# TOYOTA

## Service Bulletin

Ref. No. : EG-6005

### **Subject : ENGINE DIFFICULT TO START IN HOT CONDITION**

A144028E01

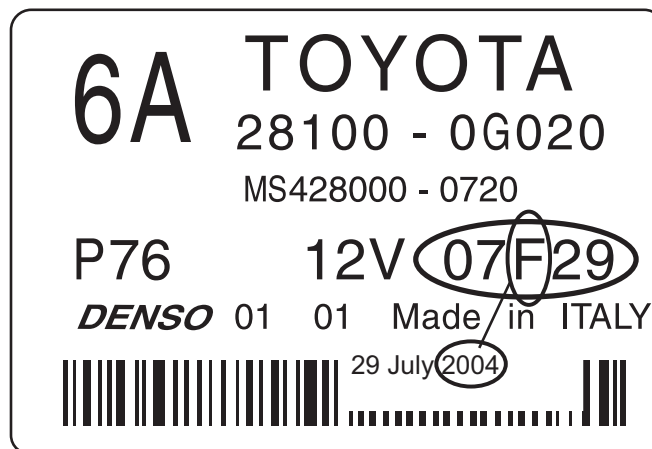
Starter motor assembly process has changed to avoid:

- Internal misalignment
- Shaft scratches

Possible discrimination is production date of the starter assy: (29/07/2004)

This date can be found on the parts label

Example: 07F29= 29 July 2004
